S E R V I C E N O T E

3497A Data Acquisition/Control Unit**Serial Numbers:** 2936A00000 / 2936A23819**Incorrectly Labeled Line Voltage Switches May Cause Switch Setting Confusion****Situation:**

**Figure 1. AC Line Voltage Switch Positions****Solution/Action:**

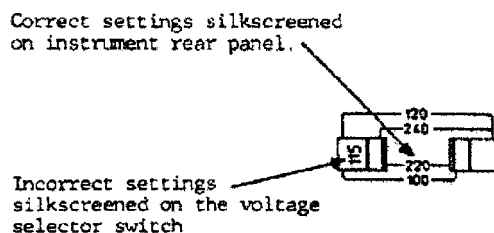
Some units may have incorrectly labeled line voltage selection switches installed. The correct settings appear silkscreened on the instrument rear panel. The incorrect settings are silkscreened on the voltage selection switches themselves.

No action is required. However, to avoid confusion, the incorrectly silkscreened line voltages may be easily scratched off using a flat-head screwdriver.
